Service Bulletin

Bulletin No.: 20-NA-063

Subject: SD Card Removed Error Message Displayed on Instrument Panel Cluster (IPC)

Brand:	Model:	Model Year:		VIN:		Engine:	Transmission:
		from	to	from	to		
Cadillac	XT4	2019	2020			All	All

5537651

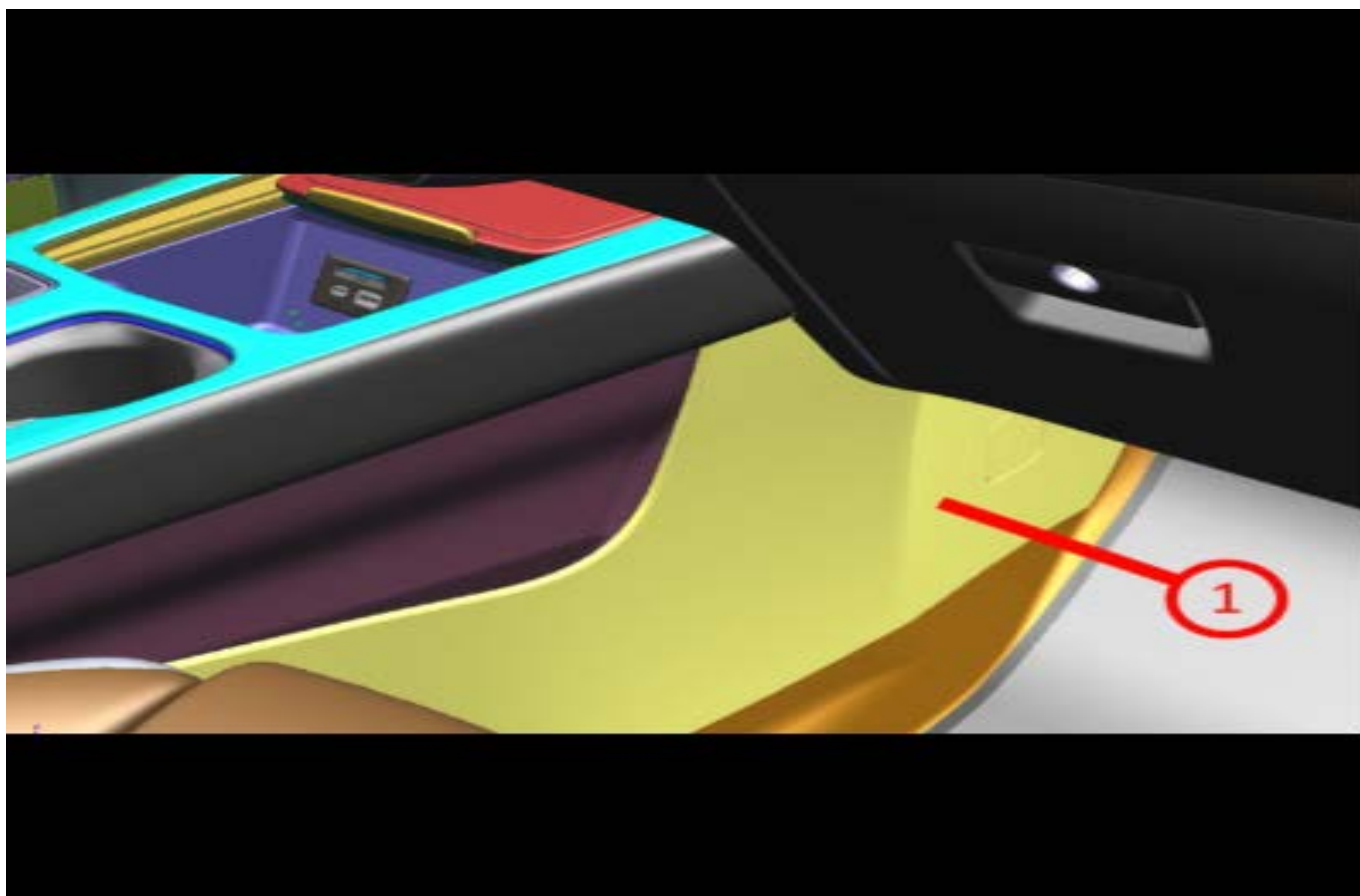
1. Partially remove the USB HUB (1). Follow the *Multimedia Receptacle Replacement* in SI to get to the back and locate the USB HUB ground wire.

5537654

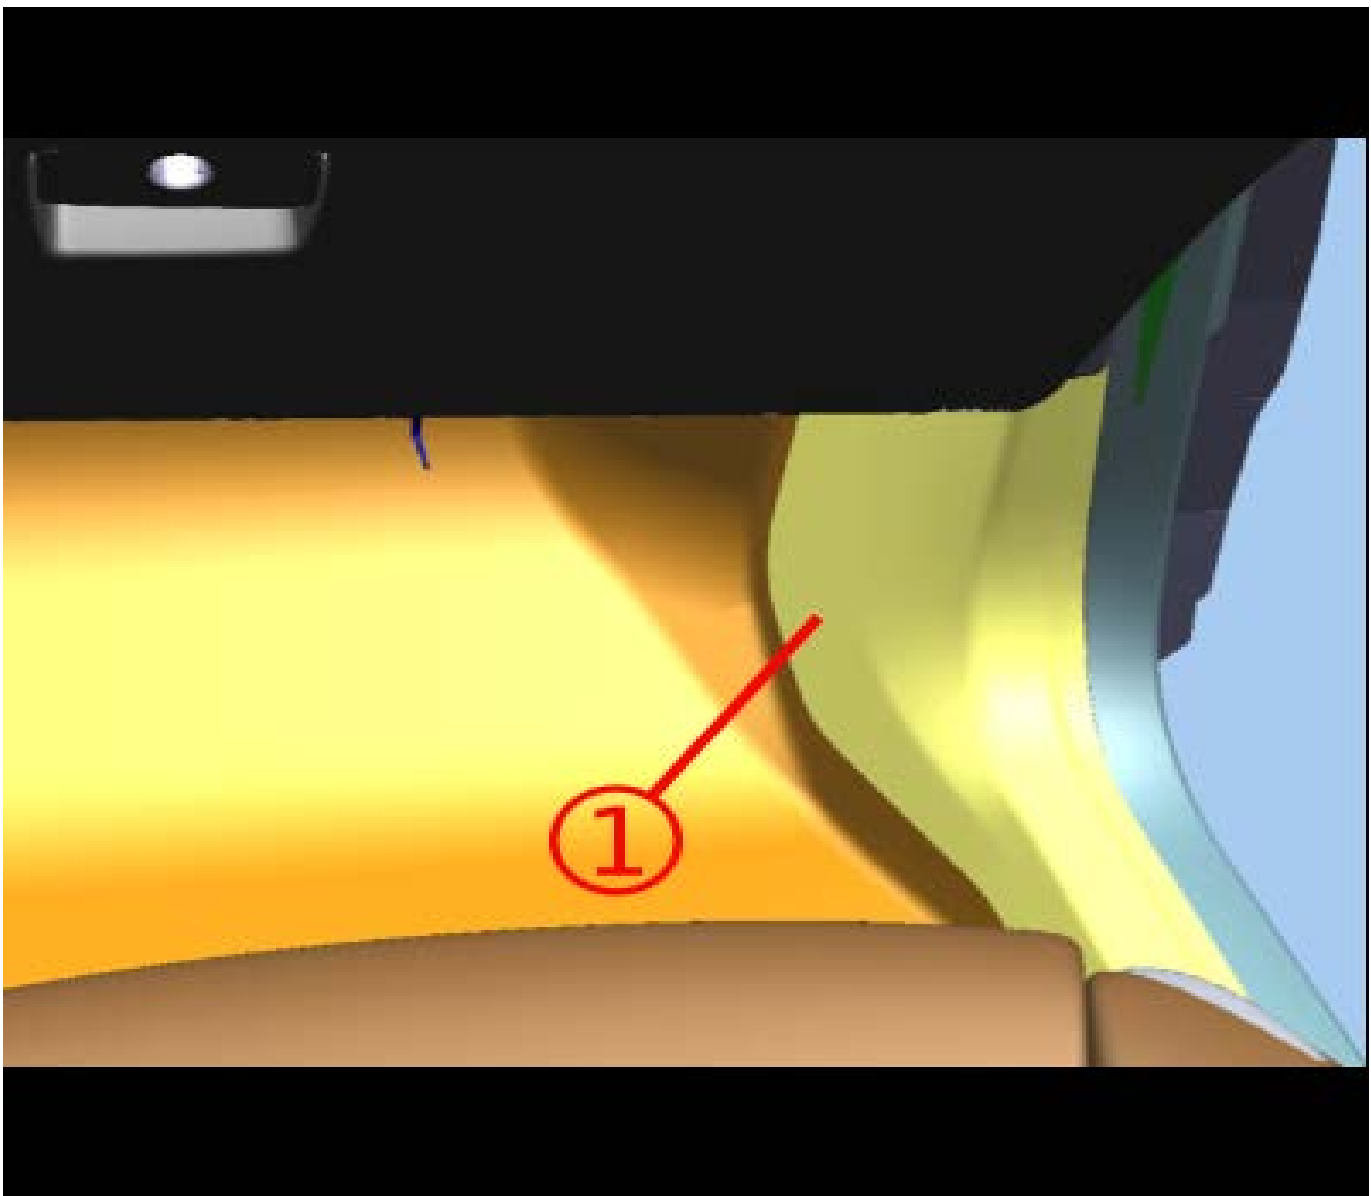
2. Cut the terminal 3 black ground wire from the USB HUB and butt connect to the USB HUB a new 0.75 mm jumper wire about 2600 mm (8.5 feet) in length. Run the wire behind the instrument panel and carpet to Ground 202 (3), located on the passenger side of the vehicle. Cut back and tape off the original ground wire with electrical tape.

5537661

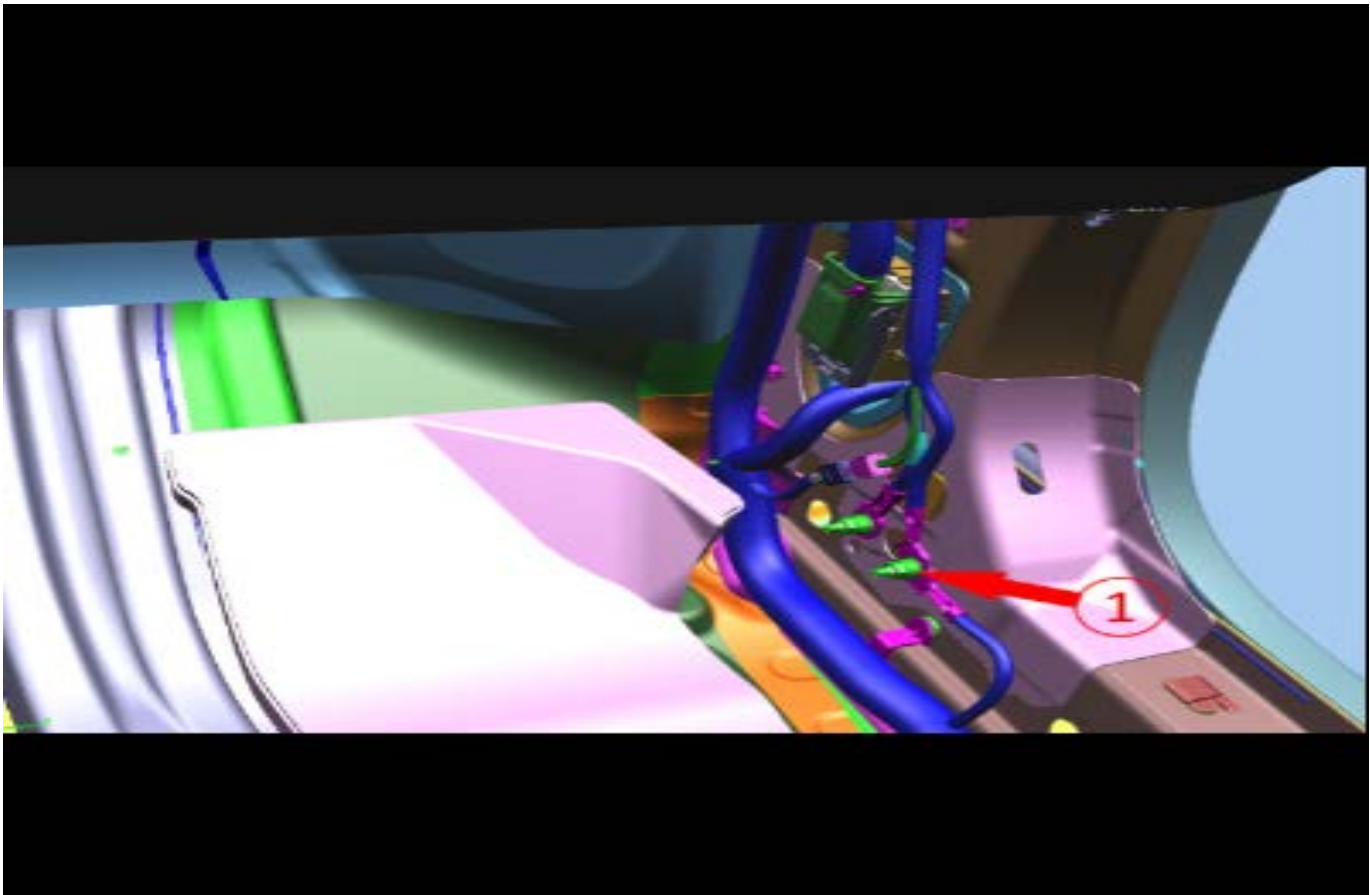
3. The front floor console extension panel (1) needs to be removed to gain access to the running wire. Refer to *Front Floor Console Extension Panel Replacement - Right Side* in SI.
